Product improvement: Added fixing pins to the socket of the fuseholder.

Fixing pins were added to the socket of the FPG7 fuseholder:

FPG7					0118.2175	
creation date	created by	release date	released by	notification no.	revision	page
2013-06-05	arnetja	2014-01-15	arnetja	25648	b	1 of 3

Old blister	New blister

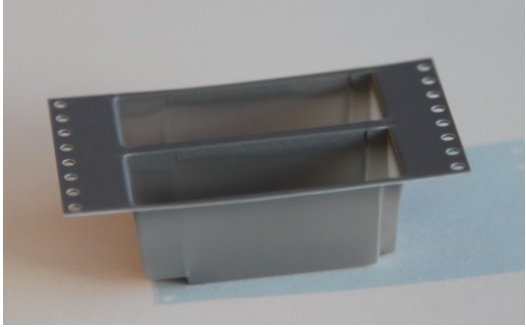
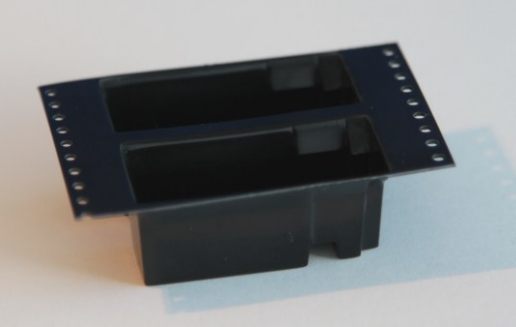
Change of packaging:

Old PCB layout	New PCB layout

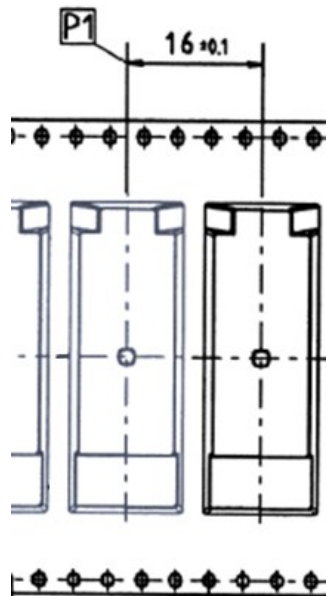
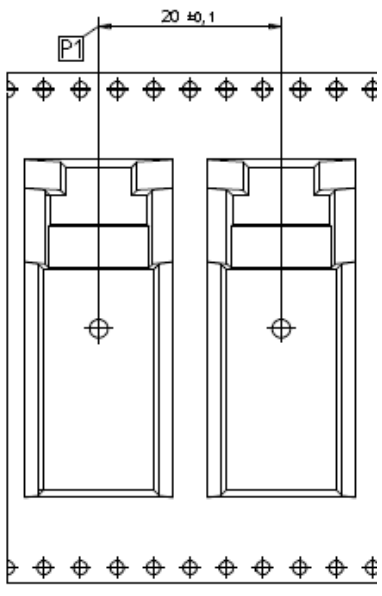
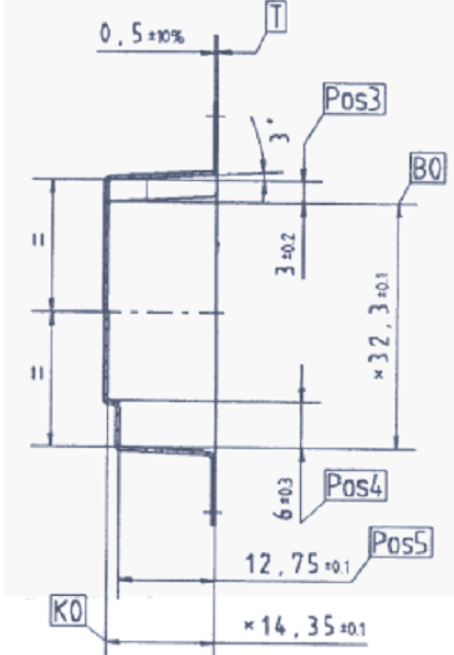
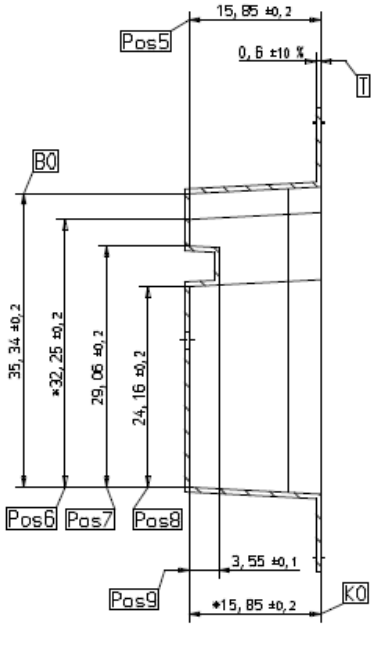
Change of PCB Layout:

Old socket	New socket

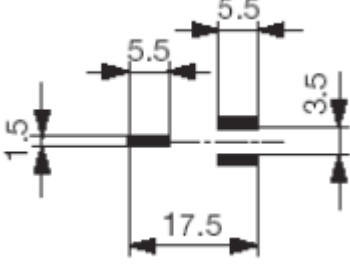
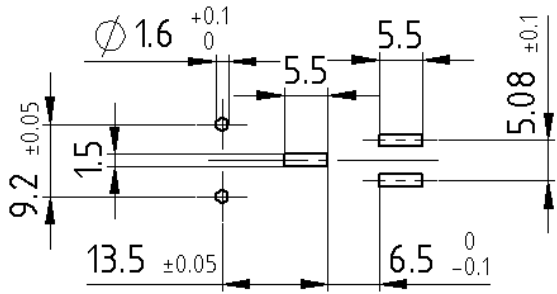
Added fixing pins to the socket of the fuseholder for stabilisation during the reflow process and for minimization of the axial force on the solder pads while exchanging the fuse.
